ADAMSTOWN BOULEVARD PHASE 1

GRANT REF: SDZ22A/0007

INTRODUCTION - PLANNING CONDITIONS

This document is in response to Condition 7 and prepared by McCauley Daye O'Connell Architects.

4.10 HOUSE TYPE H4CC AMENDMENTS TO PLANNING APPLICATION

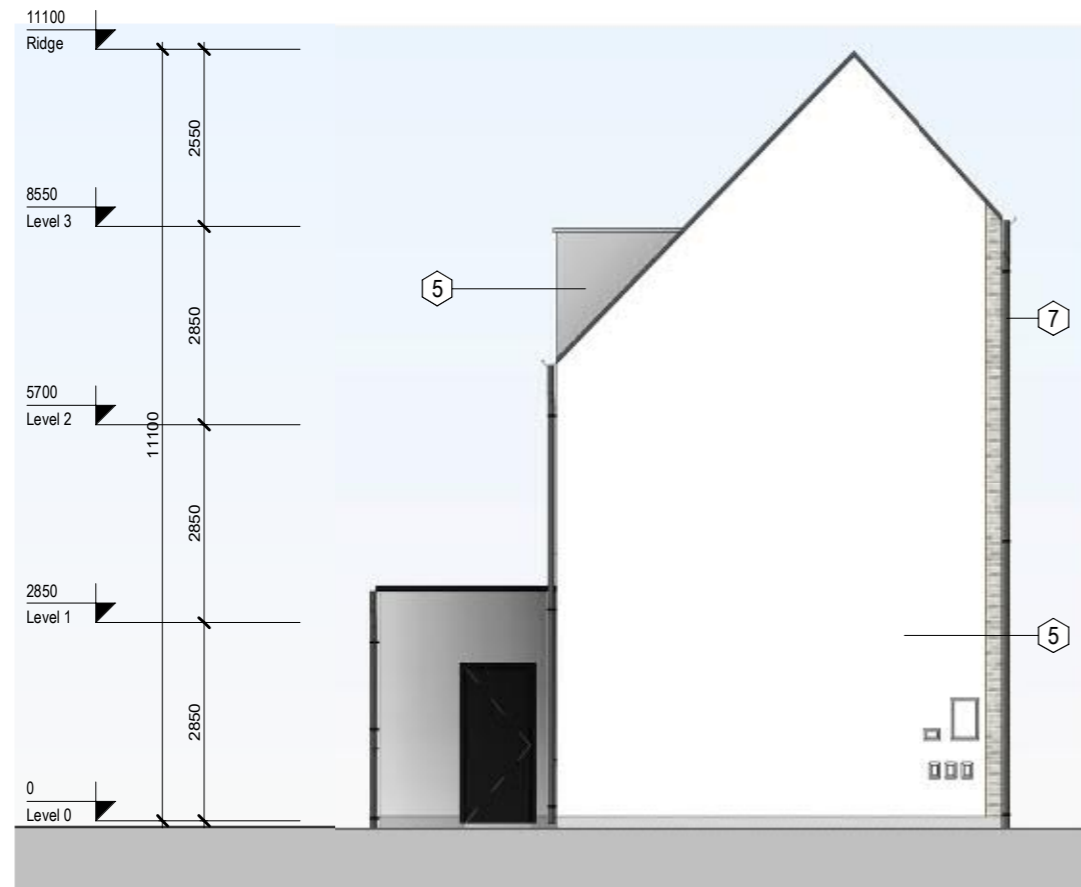
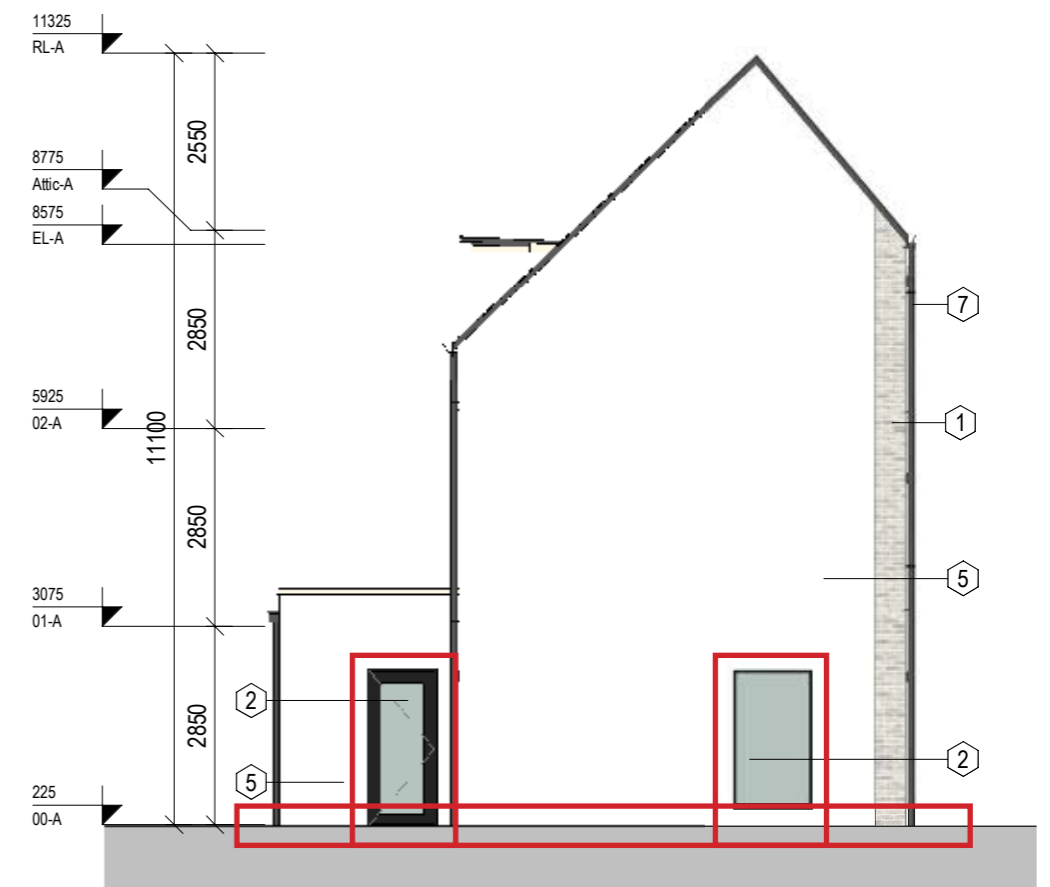
- Plinth removed
- Window introduced
- Door type changed

4.11 HOUSE TYPE H4CE AMENDMENTS TO PLANNING APPLICATION

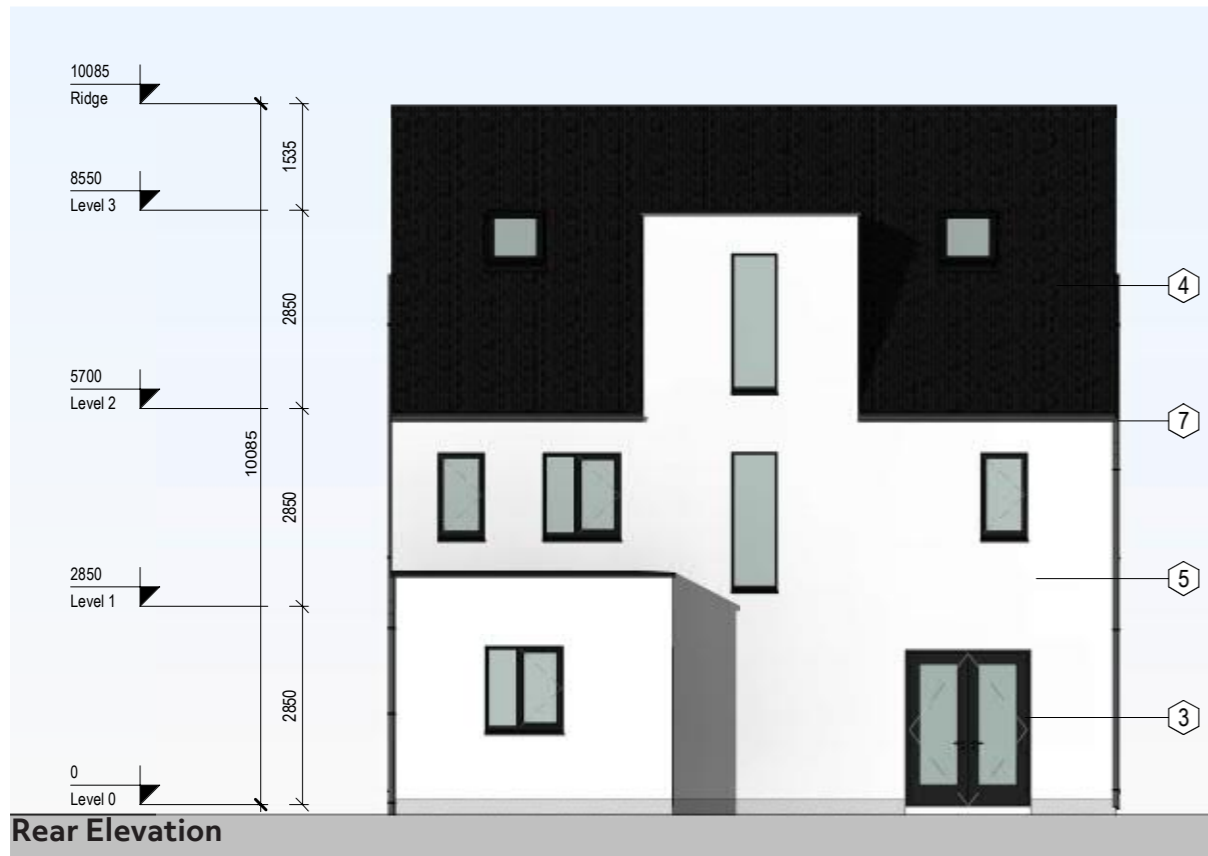
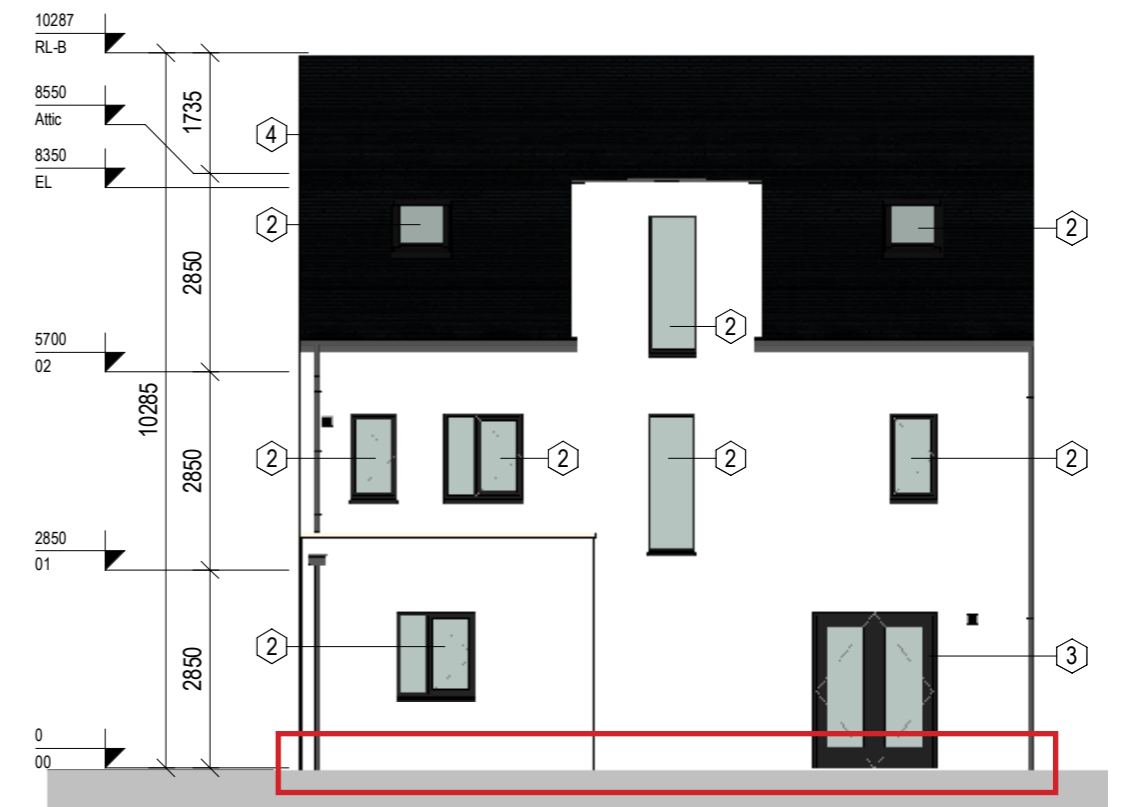
- Plinth to rear removed
- Window type and position amended
- Entrance door type amended
- Higher ridge level

4.12 HOUSE TYPE H4CEF AMENDMENTS TO PLANNING APPLICATION

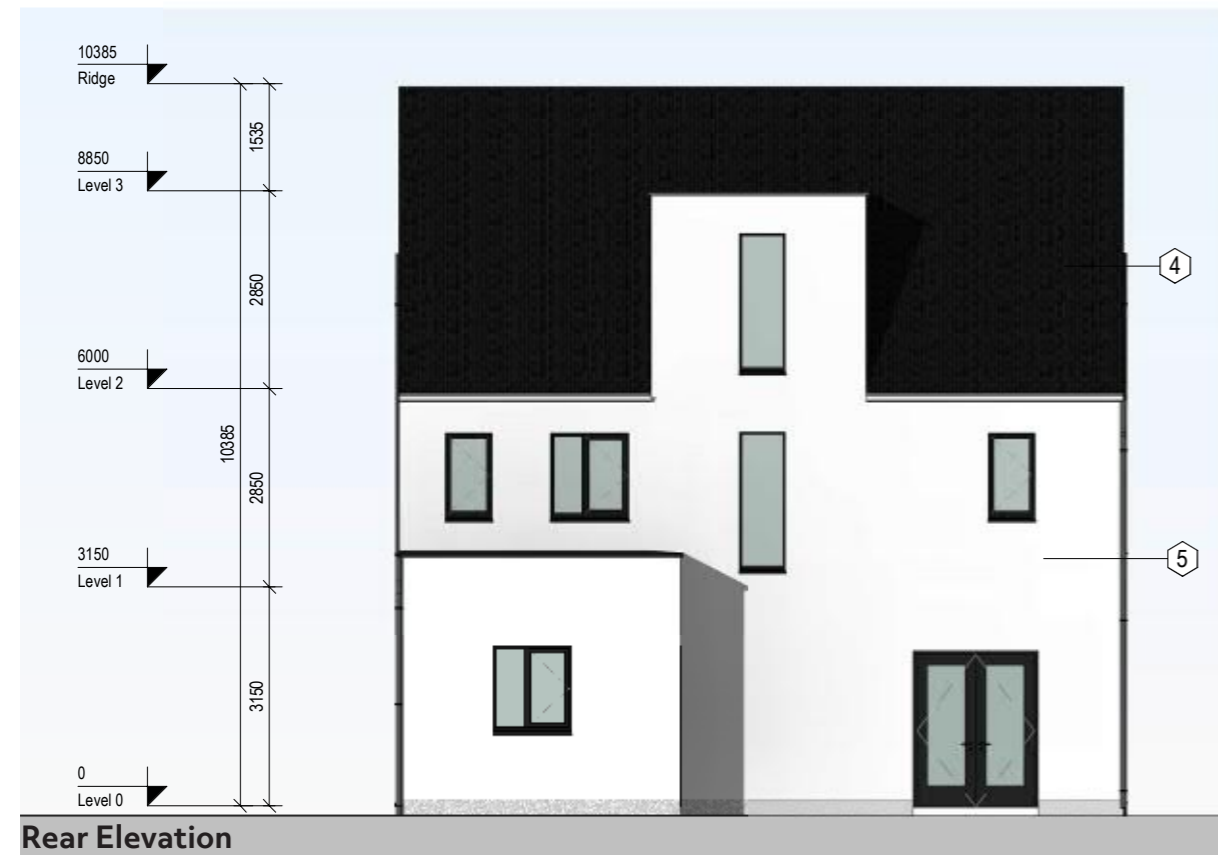
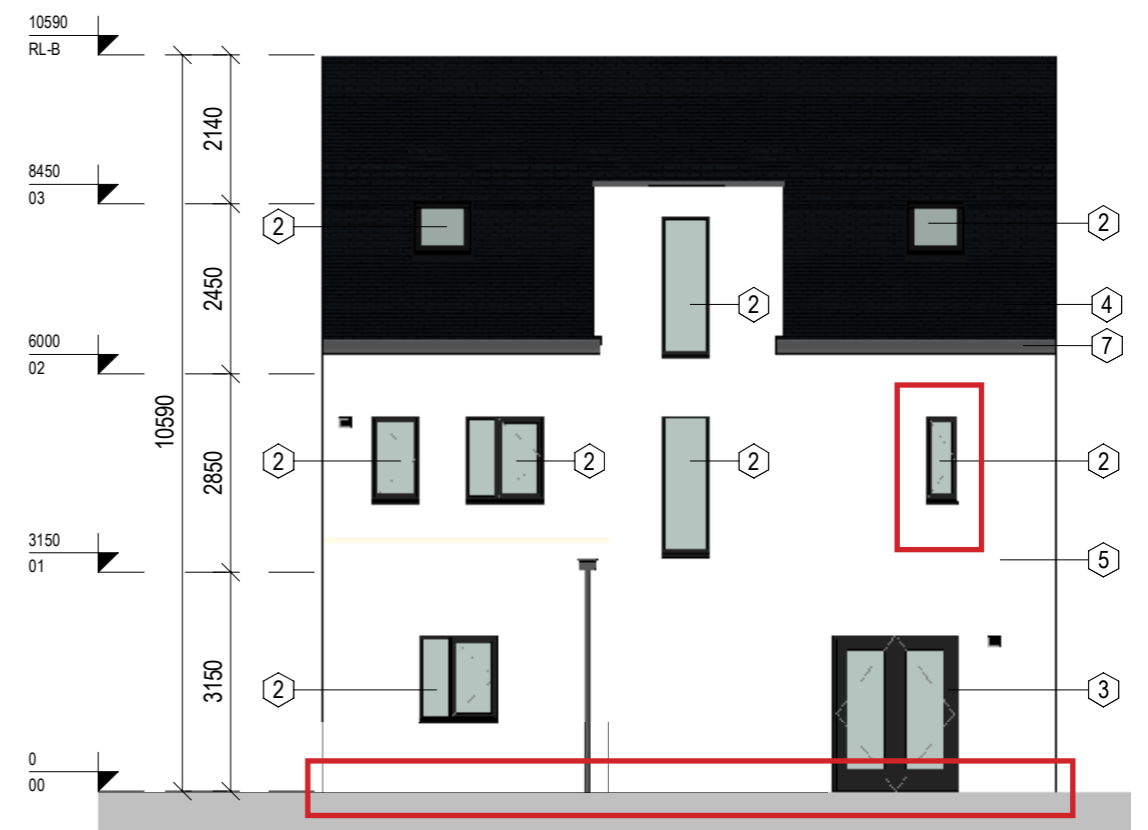
- Plinth to rear removed
- Window type amended
- Entrance door type amended
- Detail at first floor removed
- Higher ridge level

4.13 HOUSE TYPE H4HC AMENDMENTS TO PLANNING APPLICATION

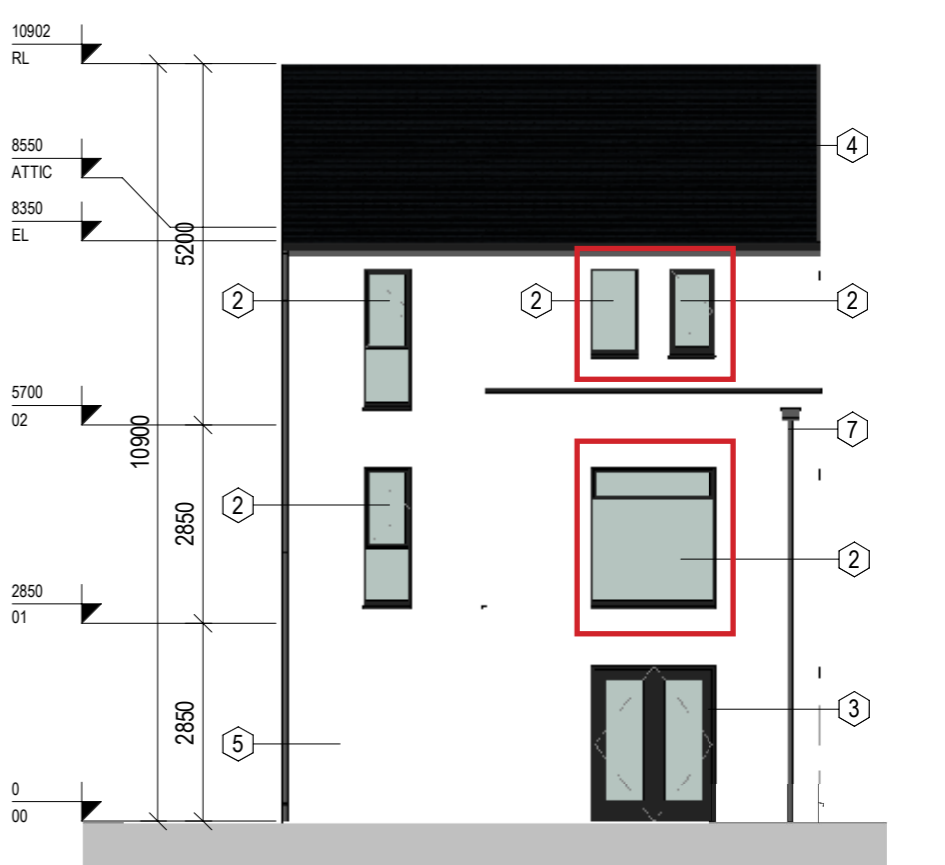
- Brick plinth introduced
- Front door side panel removed
- Windows / door brick surrounds removed
- Window type amended
- Lower ridge level

4.13 HOUSE TYPE H4HC AMENDMENTS TO PLANNING APPLICATION

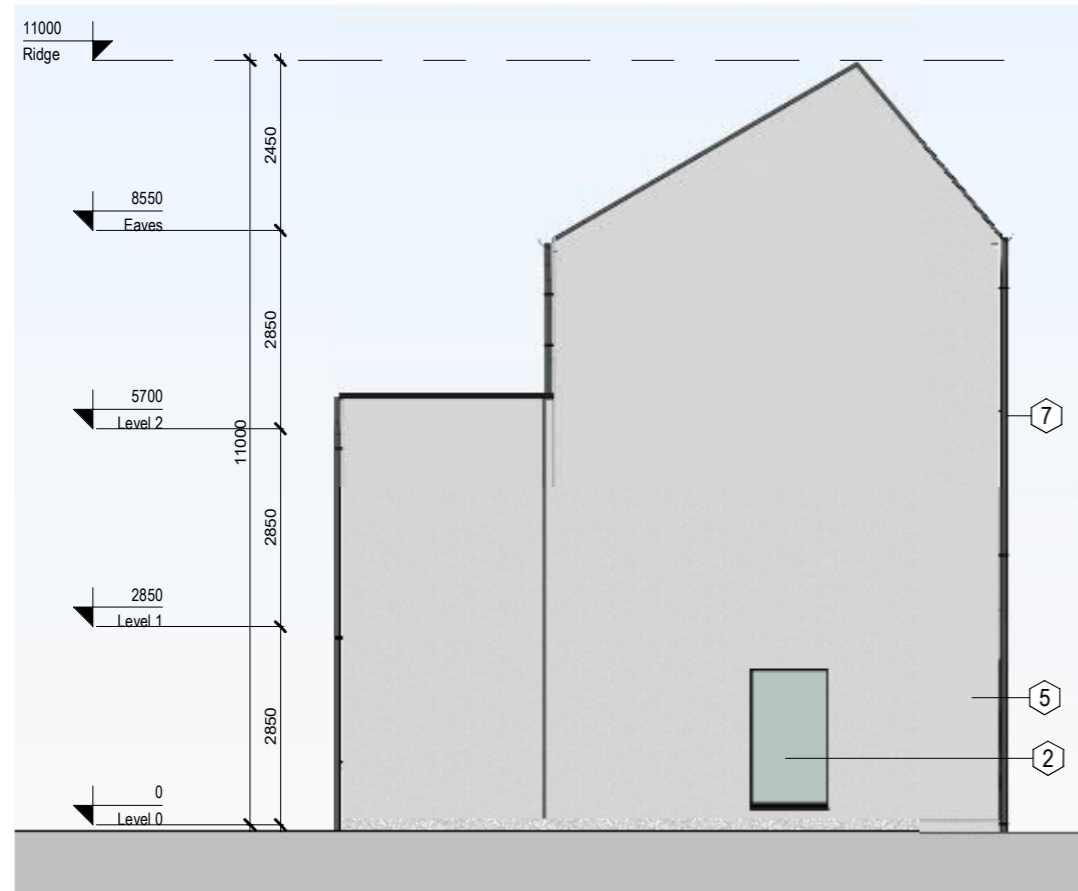
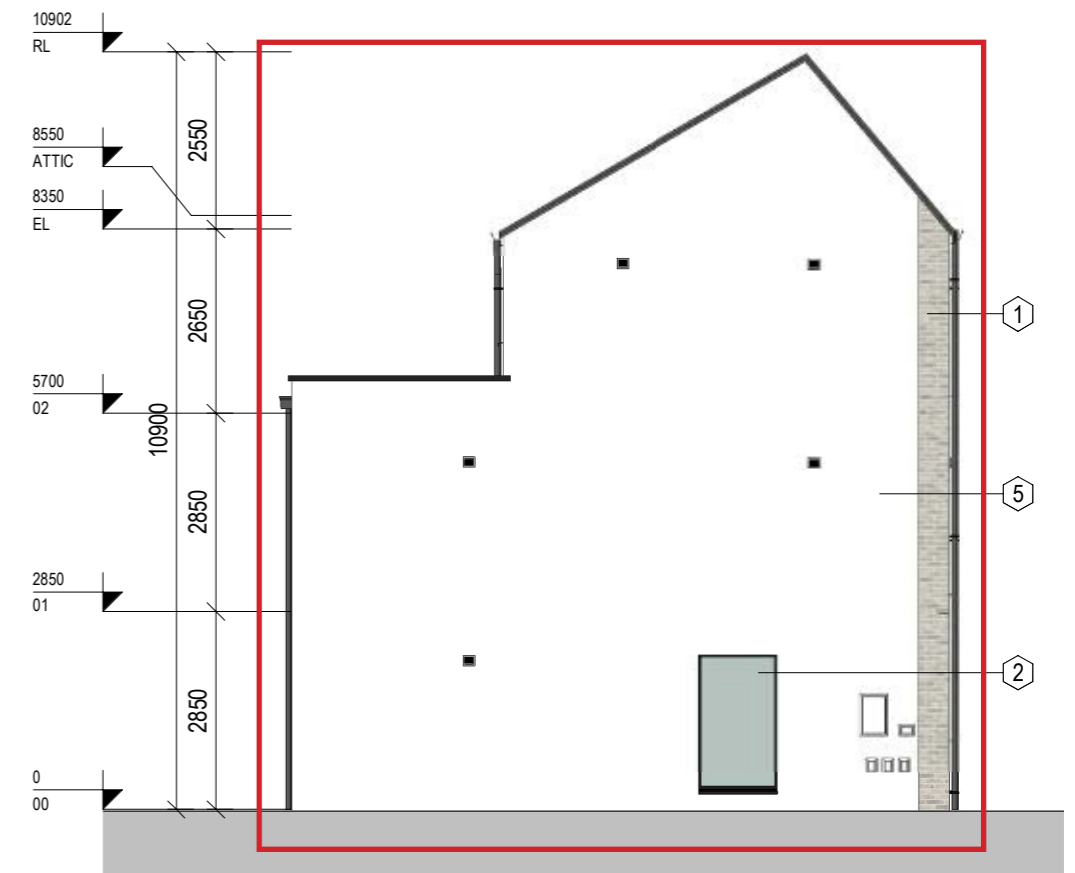
- Render colour amended
- Brick wrapped around corner
